## **REVISED RESPONSE TO REQUEST FOR ADDITIONAL INFORMATION**

**APR1400 Design Certification**

Docket No. 52-046

RAI No.:	198-8208
Review Section:	14.02 – Initial Plant Test Program – Design Certification and New License Applicants
Application Section:	14.2
Date of RAI Issue:	09/04/2015

### 14.2.12.1.24 Plant Protection System Test

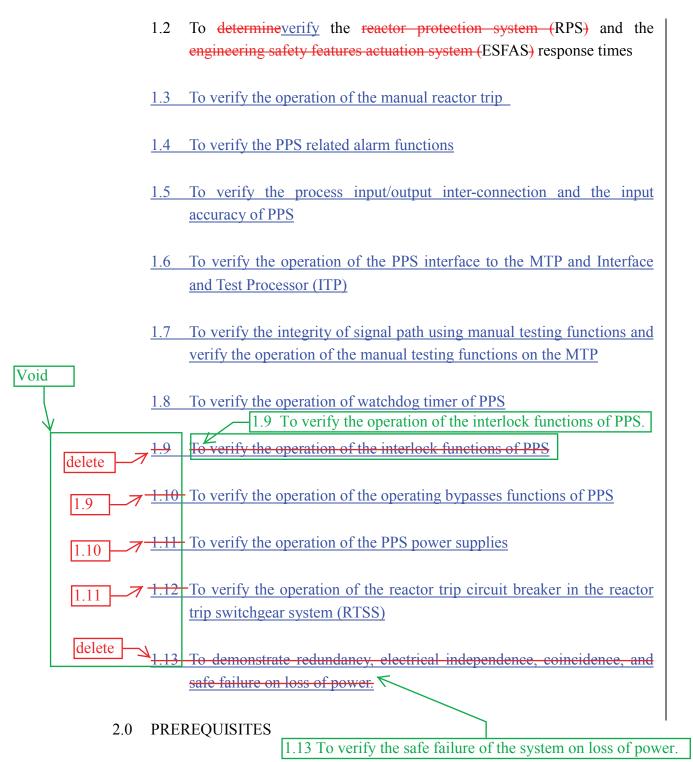
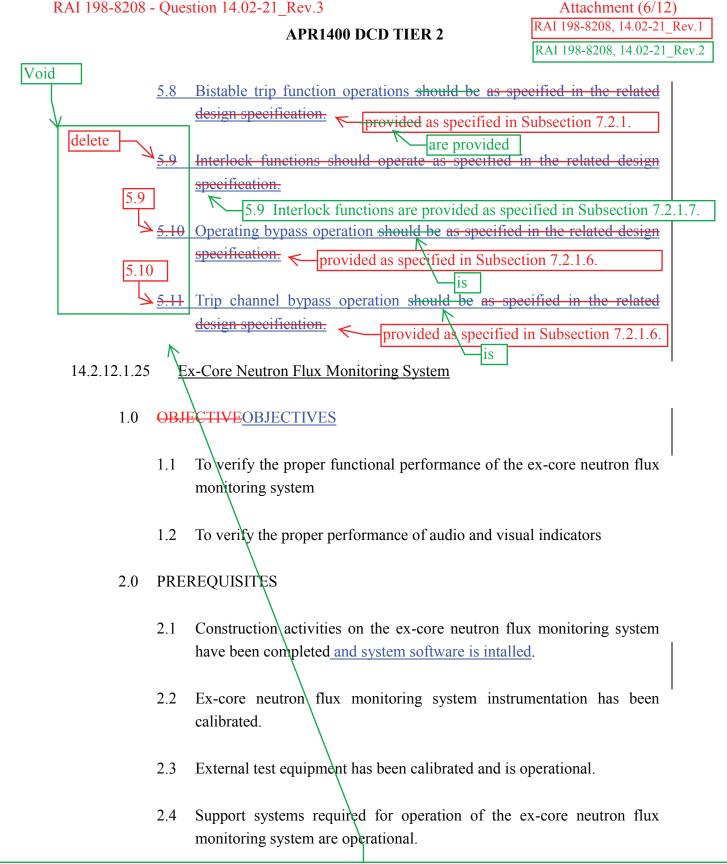
1) Item 1.0 provides the test objectives of this test. Item 1.1 states, "to demonstrate the proper operation of the [PPS]." This test objective does not contain specific criteria that need to be met. In addition, the staff finds that portions of the test methods listed under Section 14.2.12.1.24, Item 3.0, "Test Method," appear to be test objectives. For example, Item 3.11 under "Test Methods" states, "Verify proper operation of the core protection calculator system by input/output and internal function tests." In this case, verifying the proper operation of the core protection calculator system should be a test objective. As such, the staff requests the applicant to provide specific objectives that should be met with this test.

2) Item 2.0, provides prerequisites for the PPS test. The staff finds that these prerequisites are not sufficiently specific to determine what systems need to be functional to perform this

test. For example, it states "Support systems required for operation of the trip circuit breakers, ESF-CCS and PPS are operational" It is not clear what these support systems are. It is also unclear what inputs to the PPS is required for the completion of this test. In addition, clarify whether the factory acceptance testing needs to be complete prior to conducting this test. As such, the staff requests the applicant to provide specific prerequisites that should be met with this test.

- 3) The staff needs the following clarification in order to evaluate Item 3.0, "Test Methods."
  - a) Test Method Item 3.3, it states, "Using simulated reactor trip signals, trip each reactor trip circuit breaker with the breaker in the test position. Observe circuit breaker operation." Clarify what is the objective of this test (e.g. verify RTSS functionality). In addition, it is unclear what is meant by "with the breaker in the test position." Does this mean that the breaker is under test bypass? If so, are all the breakers under bypass or just one? The staff also requests the applicant to clarify these same issues for Item 3.4 with the circuit breakers in the operate position.

- b) Test Method Item 3.5 states "Exercise the bistable comparators using internal and external test circuitry and observe the setpoints and operation of the appropriate ESFAS logic." How do you observe the setpoints? Are the setpoints supposed to change when the bistable comparators are exercised? What is meant by exercised? Does this test intend to verify each Engineered Safety Feature Actuation System (ESFAS) function within the bistable? How do you observe the operation of the appropriate ESFAS logic (e.g. observe the output of the bistable)? Are reactor trip functions of the bistable comparators not verified? In addition, is the bistable comparator equivalent to the bistable processor specified in APR1400 FSAR Tier 2, Chapter 7?

- c) Test Method Item 3.6 states "Check the operation of trip channel bypass features including, where applicable, observation of the setpoints at which the trip bypasses are cancelled automatically." How do you observe this setpoint? What specifically is being checked with the operation of the trip channel bypass features (e.g. the capability to bypass, the modification of the voting logic when a channel is bypassed)? Does this test verify operating bypass or maintenance bypass?

- d) Test Method Item 3.7 states "Test manual trips and observe relay operation." However, the operation of the manual RT switches is not specified as a prerequisite. Is operation of manual RT switches required as a prerequisite? Is operation of manual RT switches required as a prerequisite?

- e) Test Method Item 3.8 states, "Check that low pressurizer pressure and low steam generator pressure trip setpoints track the process variable at the prescribed rate..." Where is this prescribed rate specified?

- f) Test Method Item 3.9 states, "using the installed testing devices, observe test functions and verify proper [local coincidence logic] LCL operation." What are the installed testing devices? Where is it described? What specific LCL function is being verified here (e.g. voting logic function, voting modifications when channels are bypassed or signal faults are detected)?

- g) Test Method Item 3.10 states, "Using manually initiated semi-automatic test functions to trip reactor trip breakers and ESF-CCS interfaces, observe interlock, alarm, and interface operation." Which specific interfaces does this test refer to (e.g. with non-safety systems, with the ESFAS components)?

- h) Test Method Item 3.11 states "verify proper operation of the core protection calculator input/output and internal function test." Specify the specific internal function tests that are verified.

- i) Test Method Item 3.12 states, "Inject signals into appropriate sensor or sensor terminals and measure the elapsed time to achieve tripping of the reactor trip circuit breaker or actuation of the ESFAS actuation relays. Trip or actuation paths may be tested in several segments." It appears that this test intends to verify the response time for the performance of the RT and ESFAS functions from sensor to final actuation device. Does this test verify the response time for every RT and ESFAS function?

- j) Is there a specific integrated test that verifies the functionality of the entire RT and ESFAS train? If not, provide an integrated test to verify the functionality of the entire RT and ESFAS train.

- k) RG 1.68, Section A-1.j, "Instrumentation and Control Systems" specify that "tests should be conducted, as appropriate, to verify redundancy and electrical independence." What tests are performed to verify redundancy and electrical independence within the PPS?

4) Item 5.1, under "Acceptance Criteria" states that "The PPS performs as described in Sections 7.2 and 7.3." The staff finds the information provided in this reference includes a significant amount of design information. However it is unclear what specific design criteria is being referenced as acceptance criteria for this test. Clarify what specific design criteria within FSAR Tier 2 Sections 7.2 and 7.3 provide the acceptance criteria for the PPS test.

- 1) The Objectives in DCD Tier 2 Section 14.2.12.1.24 will be updated to add eleven items pertaining to specific test objectives to demonstrate the proper operation of the plant protection system (PPS). The objective for verification of the PPS interlock function will be added from Revision 1 as Objective 1.9 with associated additions to the test methods and acceptance criteria. A paragraph will be added to the test method section to provide descriptions of the verification of redundancy and electrical independence within the PPS. Verification that the outputs of the PPS will go to a predefined state on restoration of power will be restored as Objective 1.13 with related test method and acceptance criterion added to the test plan. Objective 1.1 will be further clarified to demonstrate proper operation of the bistable logic and coincidence logic of the PPS since the other added objectives in their entirety demonstrate proper operation of the system. Item 3.11 which appeared to be an objective rather than a test method will be removed entirely from Section 14.2.12.1.24 since it is related to the core protection calculator system (CPCS) and is not appropriate to be included in the PPS test. The test plan for the CPCS is to be provided in DCD Tier 2 Section 14.2.12.1.138, "Core Protection Calculator System Test."

- 2) The prerequisites in 14.2.12.1.24 will be revised to clarify more specifically the support systems that are needed for the test. Item 2.2 will be added to describe that the software of the PPS and engineered safety features component control system (ESF-CCS) needs to be installed. Item 2.5 will be clarified to describe the specific interface systems required for completion of the test; namely, CPCS, reactor trip switchgear system (RTSS), and ESF-CCS. Factory acceptance testing does not need to be added as a prerequisite since it is a requirement of the vendor in accordance with the procurement specification and verified by the Quality Assurance program.

- 3) Clarifications to Test Methods:
  - a) The objective of the test regarding Items 3.3 and 3.4 is to confirm the functionality of the trip circuit breaker (TCB) in each division of the RTSS. This test is performed for each TCB. The TCB can be switched from the CONNECT position to the TEST position or vice versa. When in the TEST position, the TCB is operational for test purposes only. When in the CONNECT position, the TCB becomes fully operational either for testing or for normal operation. Item 3.3 will be revised to specify the TCBs in the RTSS and the operate position in Item 3.4 will be corrected to the CONNECT position.

Item 3.2 will be deleted since it is an unnecessary test item for verifying the PPS functionality. As a result, Items 3.3 and 3.4 will be re-numbered as Items 3.2 and 3.3.

b) The bistable comparison logic is part of the bistable application program loaded in the bistable processor. The bistable logic test is performed based on the manual test procedures using the maintenance and test panel (MTP). While the bistable comparison logic test is performed, the setpoints of each trip parameter can be observed in the operator module (OM) in the main control room (MCR). The engineered safety features actuation system (ESFAS) function is not verified by performing the bistable comparison logic test. Therefore, the wording of Item 3.5 will

The main purpose of the bistable logic test is to verify that a partial pre-trip and trip signals are properly initiated by simulating the pre-trip and trip conditions for each trip parameter. Therefore, an additional item (Item 3.5) will be added to the test methods to perform a coincidence logic test using the MTP and observing the operation of the appropriate coincidence logic.

c) Item 3.6 is to verify the operating bypass function. The trip parameters associated with the operating bypass function are high logarithmic power level, departure from nucleate boiling ratio (DNBR), local power density (LPD), and low pressurizer pressure as described in DCD Tier 2 Section 7.2.1.6, "Bypasses".

Item 3.6 will be modified to clarify the test method to simply check the operation of the operating bypass logic and switches to align more closely with the intent of the test as discussed above.

- d) A prerequisite Item 2.6 will be added to ensure that the manual reactor trip and ESFAS switches in the MCR and RSR are operational. In addition, Item 3.7 will be modified to clarify that the manual RPS trips and ESFAS actuation are being tested and observation of relay operation will be deleted.
- e) Since low pressurizer pressure and low steam generator pressure trip parameters are not rate limited variables, the reference to a "prescribed rate" in Item 3.8 will be

- f) Section 4.2.1.10, "MTP Function" of the Safety I&C System technical report states that the MTP is the local human system interface (HSI) for maintenance and testing of the PPS. Therefore, the PPS testing functions are initiated from the MTP located in the I&C equipment room. Items 3.9 and 3.10 were to verify the final output of the PPS; namely, the reactor trip output and ESFAS initiation generation output. These items (Items 3.9 and 3.10) will be merged into a single item, Item 3.9, and the previous reference to installed testing devices, observation of test functions and verification of proper local coincidence logic operation will be deleted.

- g) For tripping the reactor TCB from the MTP, the specific interface system is the RTSS. Once the trip occurs in one division, then the TCB of the corresponding division will be opened; its alarm and status indication will be provided via the MTP and OM. For initiating ESFAS, the interface system is ESF-CCS. Once one of the ESFAS signals is initiated, then the related alarm and status indication of the corresponding ESF-CCS division will be provided via the MTP and OM. As stated previously in f) above, Items 3.9 and 3.10 will be merged into Item 3.9 and the test method description clarified.

- h) As stated in response to sub-question 1), the CPCS test item 3.11 will be deleted from Section 14.2.12.1.24. The test plan for the CPCS is to be provided in DCD Tier 2 Section 14.2.12.1.138, "Core Protection Calculator System Test."

- i) The response time test stated will be performed for every RT and ESFAS trip parameter. The response time test results should be within the response time requirements specified in DCD Tier 2 Table 7.2-5 for each trip parameter.

- j) The functionality of the entire division of the reactor trip path is verified through the divided, but overlapped portions of the tests as shown in Figure 4-6, "Overlap in Functional Testing for the PPS" of the Safety I&C System technical report and Figure 7.2-11, "PPS Testing Overlap" of DCD Tier 2. To be more specific, the overlap between the following tests verifies the entire division of the reactor trip path as shown in Figure 7.2-11 of DCD Tier 2: transmitter test, analog input test, bistable logic test, reactor trip local coincidence logic test, reactor trip initiation test, and engineered safety features local coincidence logic test.

- k) PPS is demonstrated through the testing specified in Tier 1 Section 2.5.1.1 and Table 2.5.1-5 ITAAC Item 3.b. To verify redundancy and electrical independence within the PPS for the as installed system, the tests in DCD Tier 2 Section 14.2.12.1.24 Item 3.0, "Test Method" are conducted separately for each safety division. Observations are performed both within the division under test and concurrently of the other divisions. This will be described in DCD Tier 2 Section 14.2.12.1.24 Item 3.0, "Test Method." DCD Tier 2 Section 14.2.12.1.138 "Core Protection Calculator System Test" will be revised to provide details relating specifically to the testing of the CPCS system design attributes, including redundancy and independence.

- 4) The Acceptance Criteria Item 5.1 is to ensure that the safety functions of the PPS specified in Sections 7.2 and 7.3 are met; that is, to successfully generate reactor trip and ESFAS initiation signals.

Item 5.1 will be modified as follows: The PPS performs <u>the safety functions</u> as described in Sections 7.2 and 7.3.

An additional eight Acceptance Criteria items (Items 5.3 to 5.10) have been added to the test to ensure that the pertinent objectives have been met and include, adequate operation of the power supplies, fiber optic interconnections, PPS/APC-S interconnection, alarm operation, manual trip operation from the MCR/RSR, bistable trip function, operating bypass function, and trip channel bypass function.

The term "should be" will be revised to "is" or "are" to provide a more definitive requirement for the as-installed system to meet the acceptance criteria listed for all items in 5.0.
